ASR Pipeline Cathodic Protection System Replacement

Solicitation Number: CO-00619

ADDENDUM 2

October 26, 2023

DRAWING NUMBER
P-14

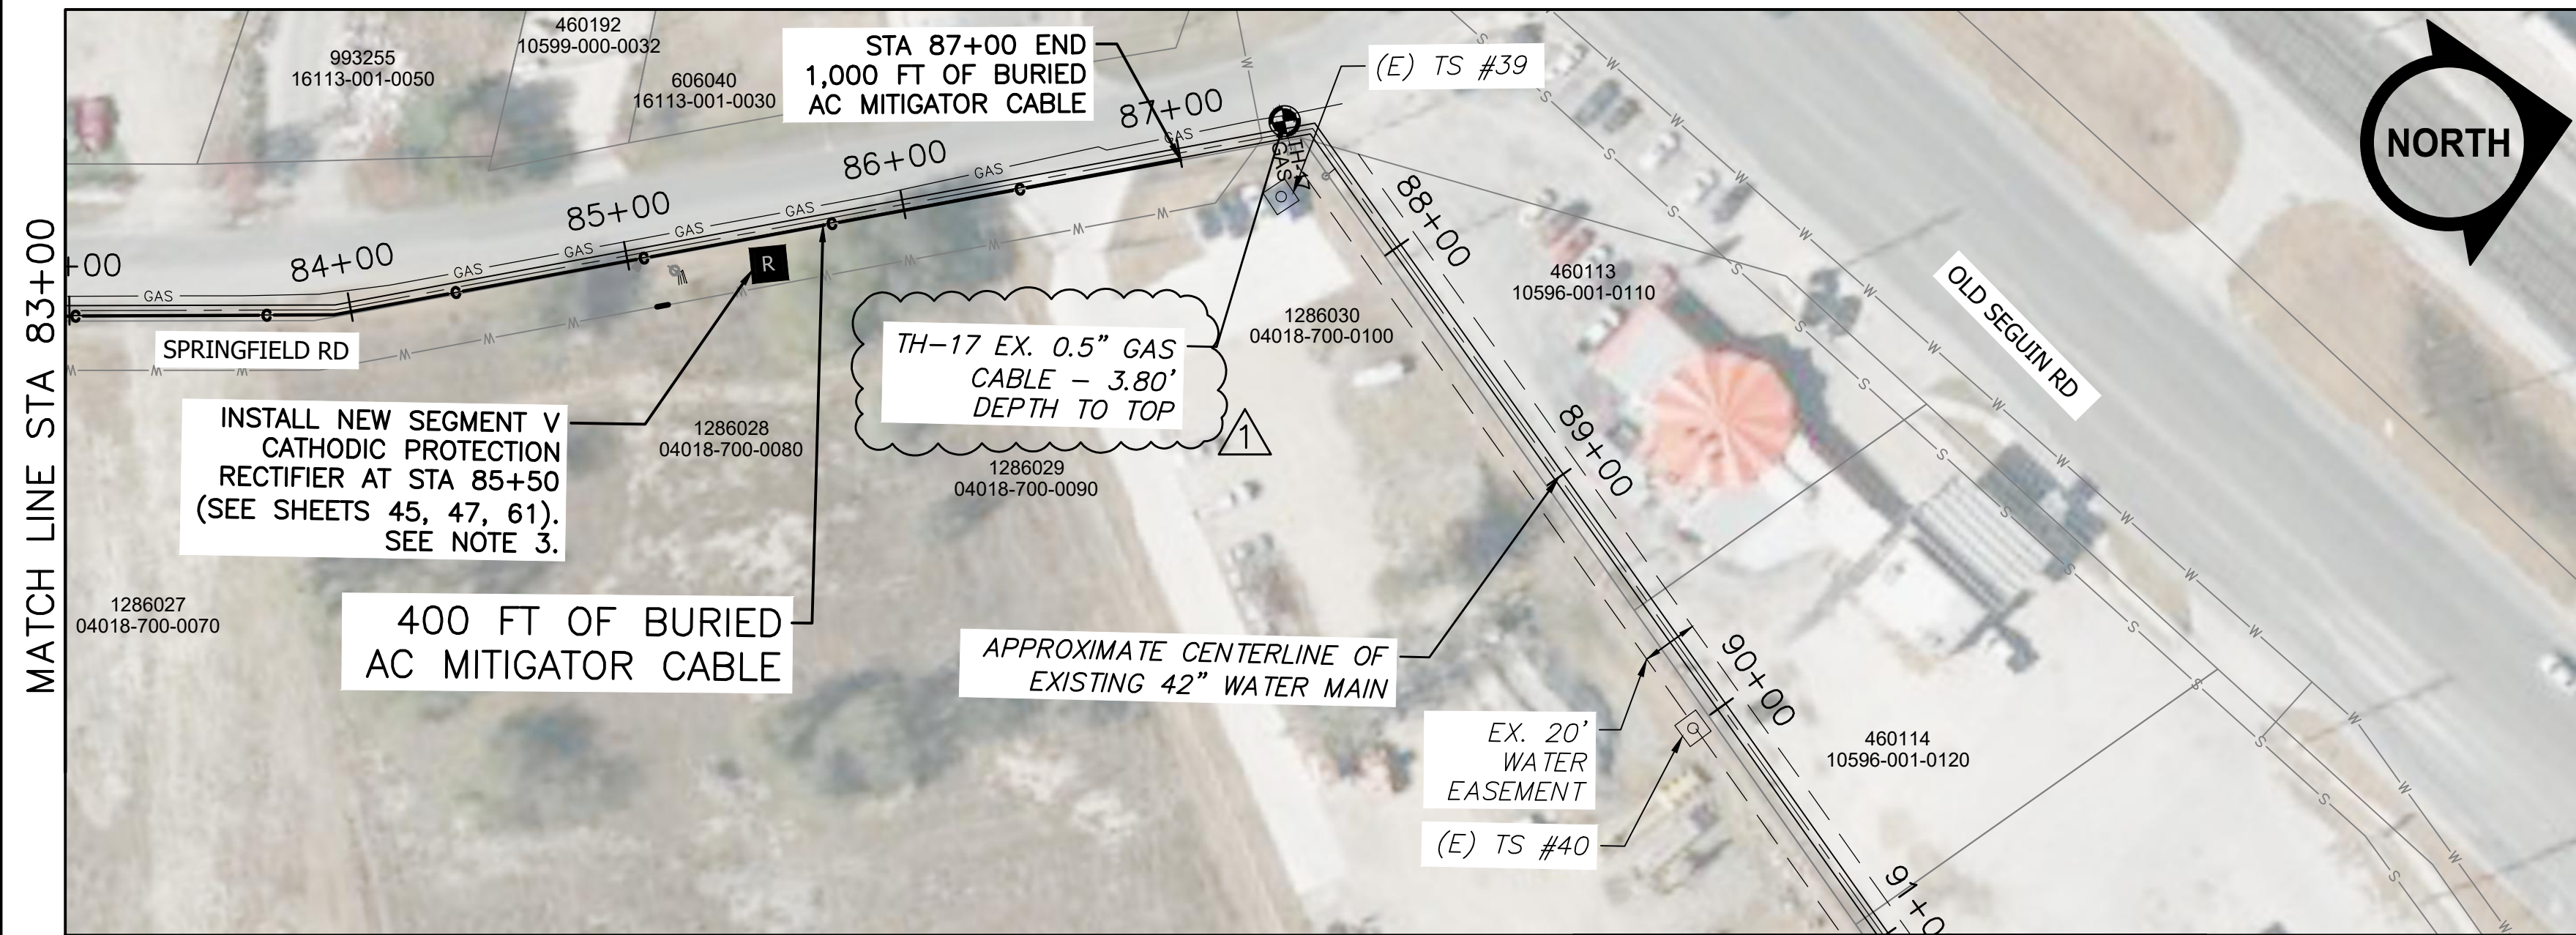
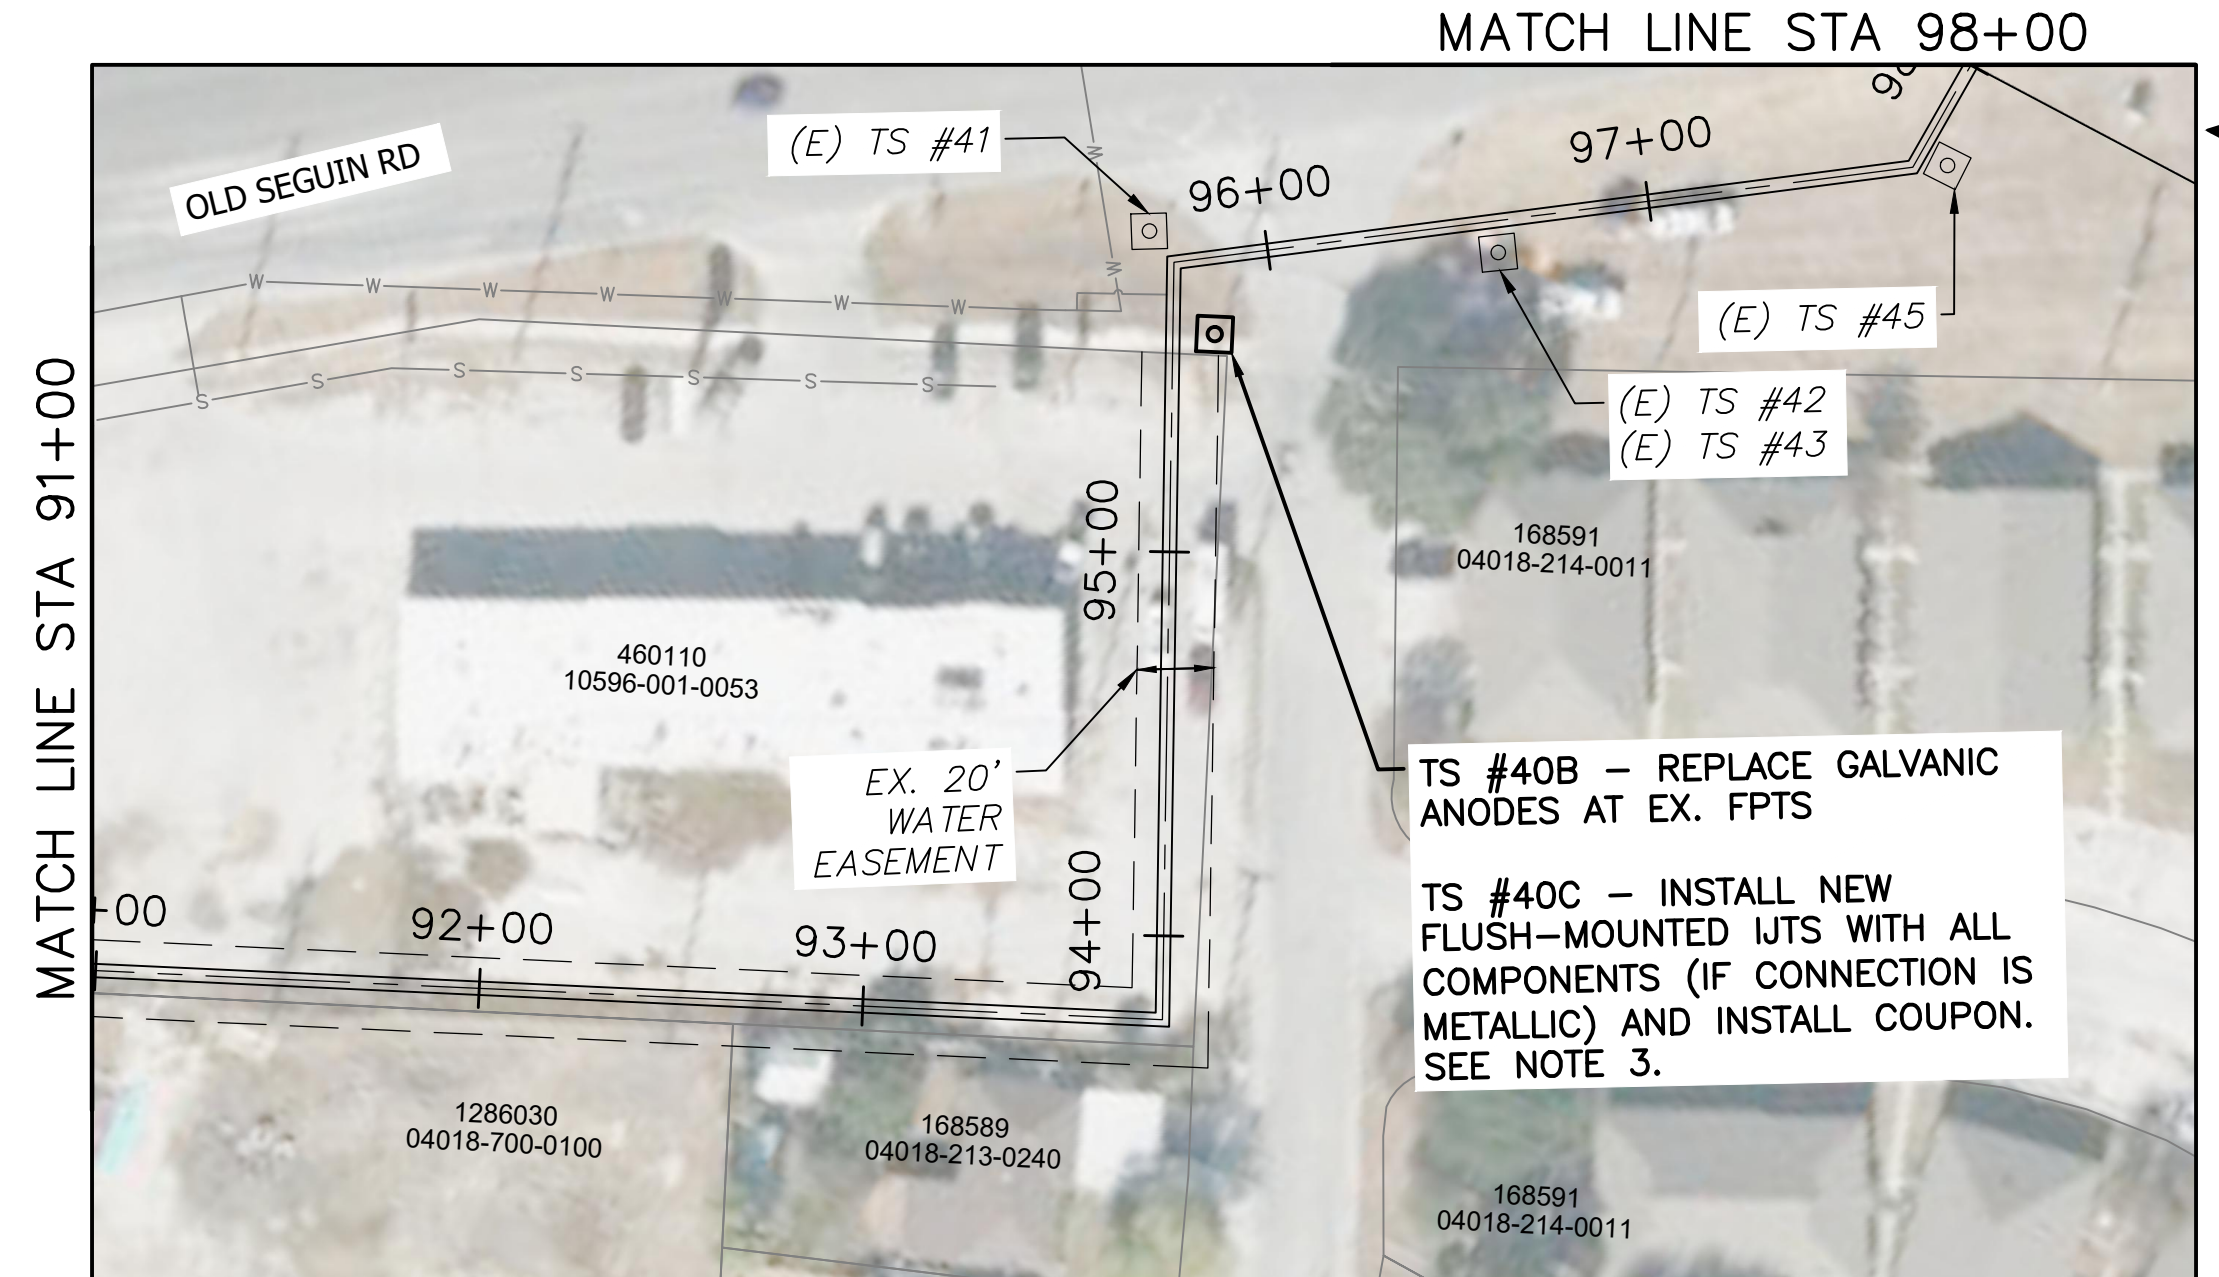
6. **Question: Page 24 of CO_00619_ASR CP System Replacement Plan SS, shows TS #31 is to receive replacement anodes, but on page 45 of the same document Segment 5 does not call out test station #31 in the Cathodic Protection Schedule.**

Response: It is understood this question pertains to drawing number P-14. The callout for Test Station #31 on the plan sheets should read Test Station #30. TS #30 should be replaced with a flush mounted IJTS as indicated on drawing P-14. Replacement anodes are not required for TS #30. Please refer to "Changes to the Plans", item 3 in this Addendum.

3. Sheet P-14 – Segment V Plan (STA 69+00 to 98+00)

REMOVE and REPLACE in its entirety with attached Sheet P-14.
